ARCHITECTURAL REVIEW BOARD MEETING

PROJECT COMMENTS

PROJECT NUMBER: SP2024-046
PROJECT NAME: Site Plan for 2686 S. Goliad Street
SITE ADDRESS/LOCATIONS: 2686 S GOLIAD ST

PROJECT NUMBER: SP2024-048
PROJECT NAME: Site Plan for River Dog Retreat
SITE ADDRESS/LOCATIONS: 100 S JOHN KING BLVD, ROCKWALL, TX 75087

JOB NO. 3036-21	DESIGN BY AGU
CREATED	CODE
PLOTTED 11/13/2024	CHECKED BY RDE
LAST UPDATE BY	
DRAWN: RDE	SCALE: AS NOTED
CHECKED:	DRAWING NO.: SP-1
APPROVED:	ISSUE: 0
FILENAME:

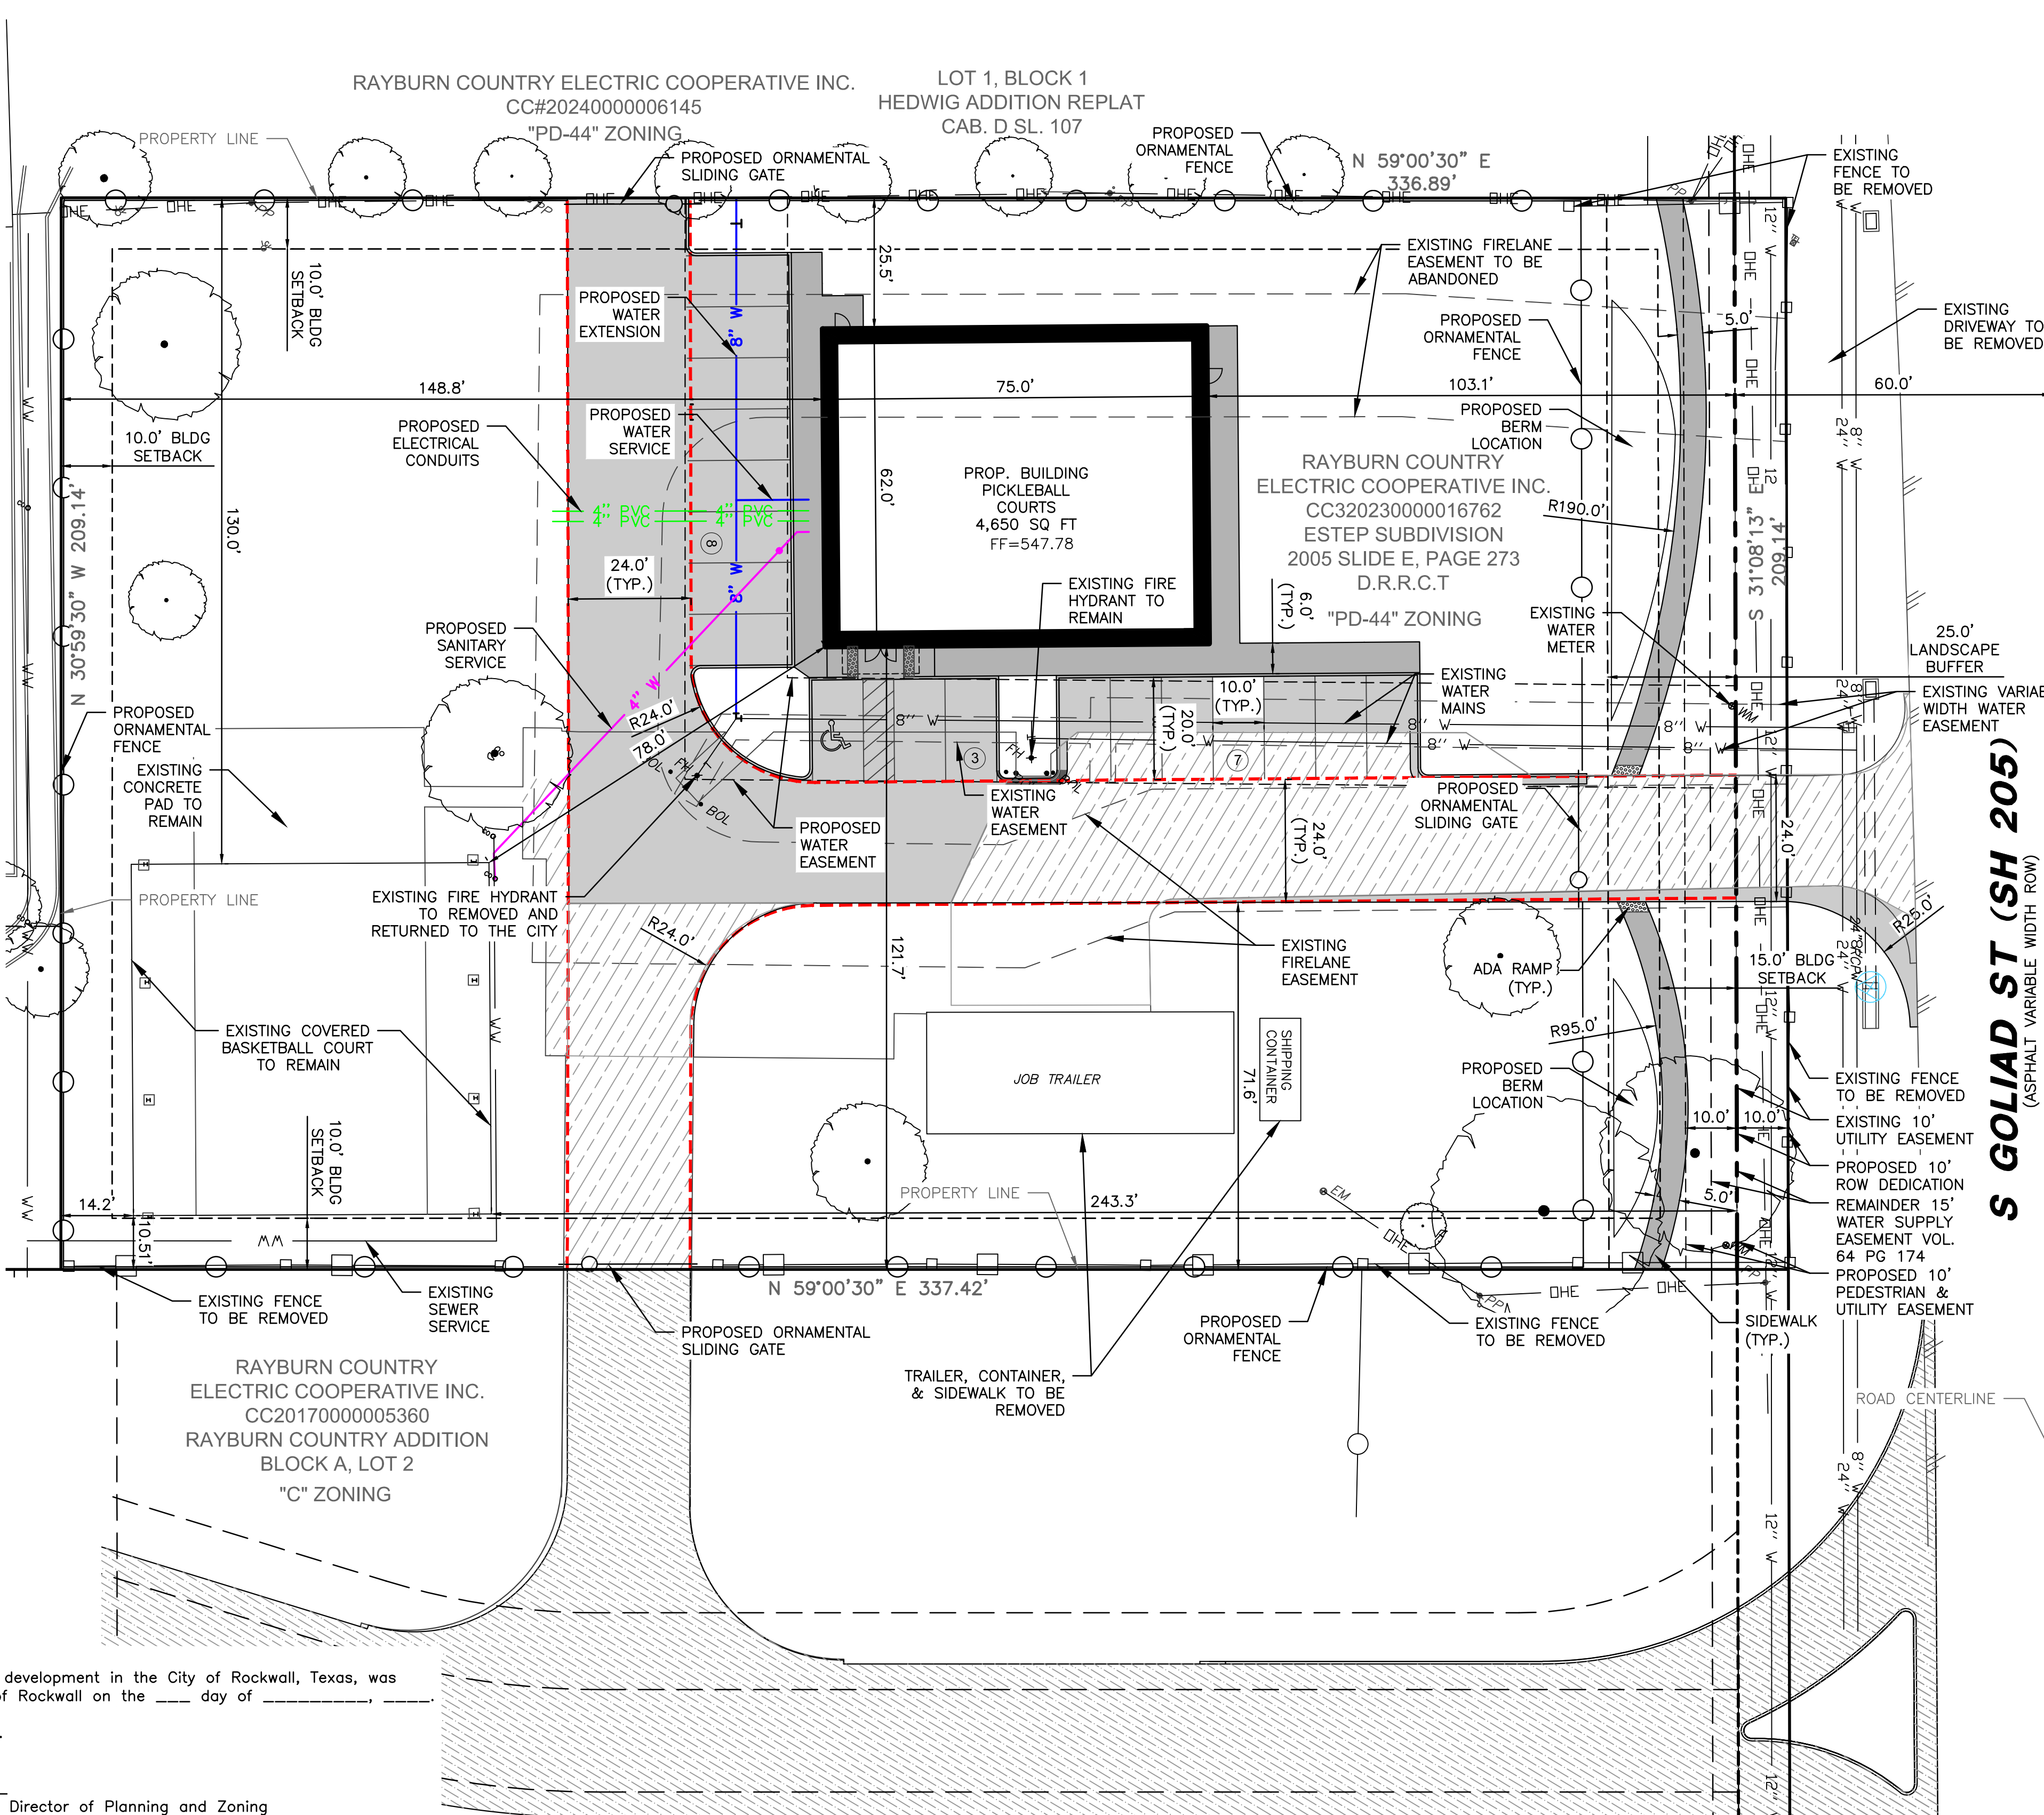
- (1) Please only delineate the building setback adjacent to S. Goliad Street. In addition, the front building setback is 25-feet. (Subsection 03.04.B, of Article 11, UDC)
- (2) Please verify how many courts will be within the facility. Based on the parking requirements shown on the site plan, there would only be two (2) courts within the building.

- (3) Please indicate the height of the proposed fencing and gates. In addition, please provide a detail of the fence and gates. (Subsection 0308.02.F, of Article 08, UDC)

- (4) Please indicate any ground mounted equipment. On the landscape plan provide the necessary five (5) gallon evergreen shrubs for screening. (Subsection 01.05. C, of Article 05, UDC)

- (5) Please clarify if there will be any RTUs. If so, they must be crosshatched on the building elevations. (Subsection 01.05. C, of Article 05, UDC)
- (6) Provide a note that there will be no outside storage or above ground storage tanks. (Subsection 01.05. D, of Article 05, UDC)

- (7) Please clarify the dumpster situation. Will there be a dumpster enclosure or will poly carts be used? Please note that poly carts must be stored within the building, and if a dumpster enclosure is proposed it must be shown on the site plan and a detail (including elevations) must be provided. (Subsection 01.05, of Article 05, UDC)

- 11/19/2024: 1. Will need a looped water main - cannot dead end this main. Is it tying into an existing main? Please clarify.
2. Fence shall "straddle" the water line easement. No poles or structures allowed in easements.
 3. Shift location so that meter is not in parking stall or sidewalk next to the building.
 4. All site drainage must go to the existing detention system.
 5. Check with the Fire Marshal to make sure that you don't need additional fire hydrants.
 6. Min 10' island
 7. Dead end fire lane is too long without a Fire Department turn around
 8. Currently not a fire lane. Need to plat as fire lane
